PZCE Case No. 2022-0129

Title 21 Text Amendment

To update the Chapter 11: Downtown zoning districts code

C. Comment / Responses – Comments Received 12/9-12/10

A. Table 21-11-5: Max Height Near Townsquare and Peratrovich Park

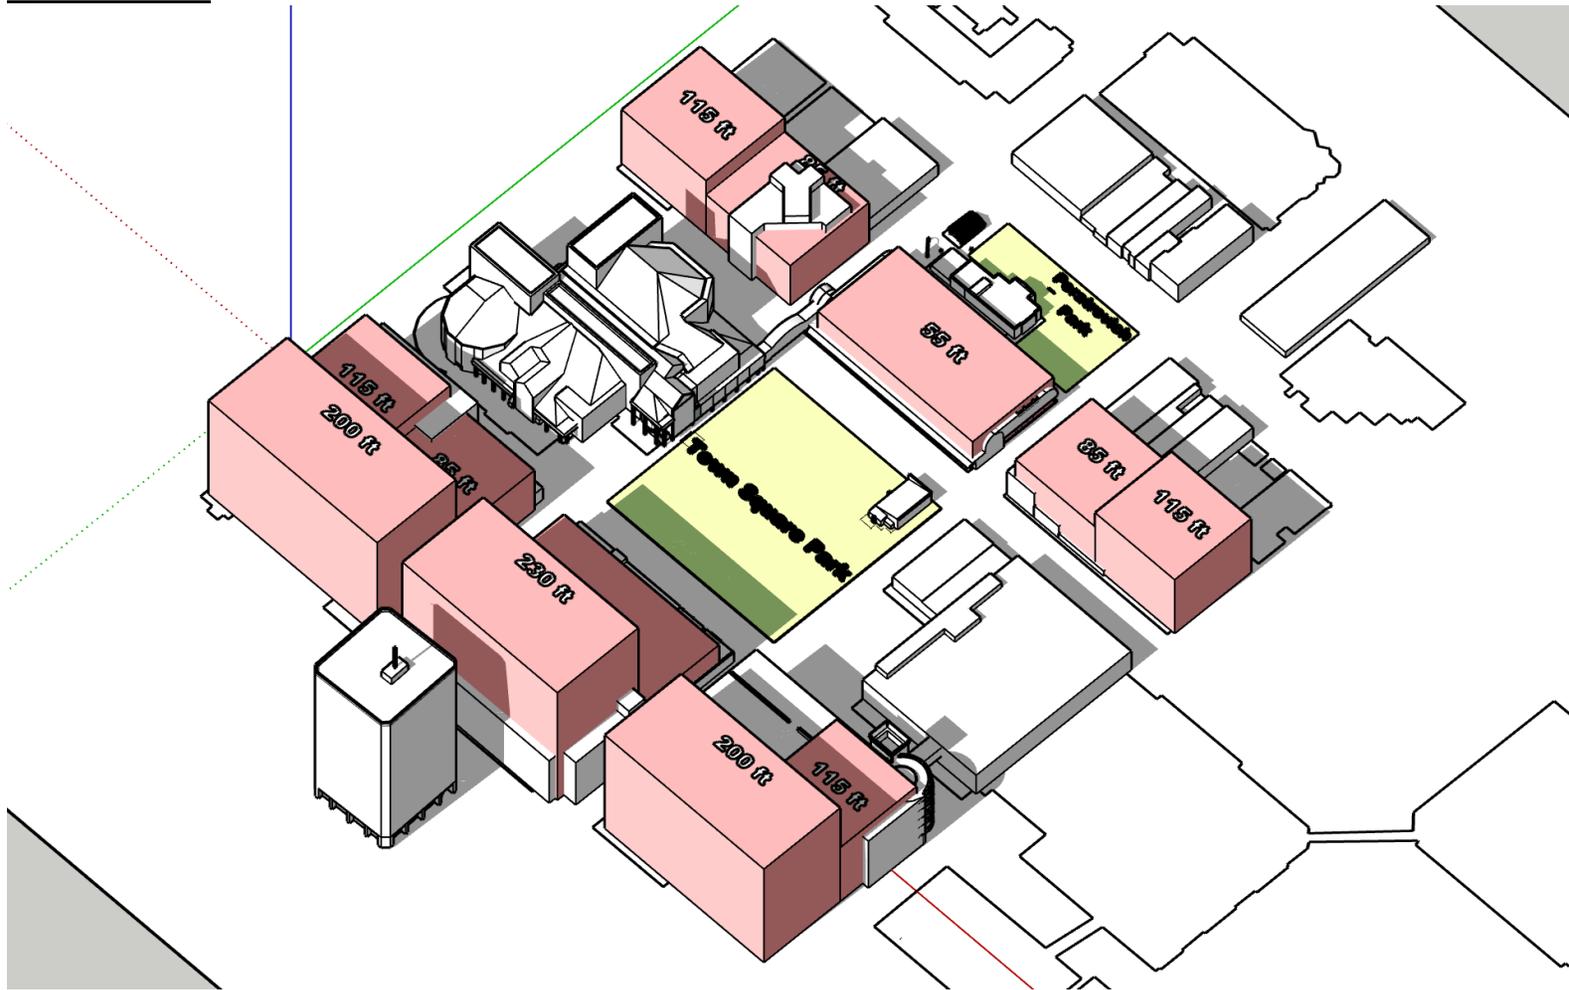
Building Articulation	21.11.070D.2.b														
Public Art	21.11.070D.2.c														
Landscaping	21.11.070D.2.d														
Decorative Lighting	21.11.070D.2.e														
Canopies	21.11.070D.2.f														
Plazas	21.11.070D.2.g														
<p>Radhika Krishna PZC, email</p>	<p>I'm hoping you could send (or share at the meeting tomorrow) a little more information about the new proposed height limitations around Peratrovich Park. Specifically, I'm wondering: -Could you point me towards a map that shows the properties affected (current and proposed)?</p>	<p>Please see the images at the beginning of this document.</p>													
<p>Radhika Krishna PZC, email</p>	<p>-How did the working group or the Planning Department determine the need for new height restrictions around Peratrovich Park?</p>	<p>Public comment regarding sun and view access led to establishing a similar guideline for this park on 4th Avenue. A solar study was performed to determine any impacts that taller buildings may pose. That study is included in this attachment.</p>
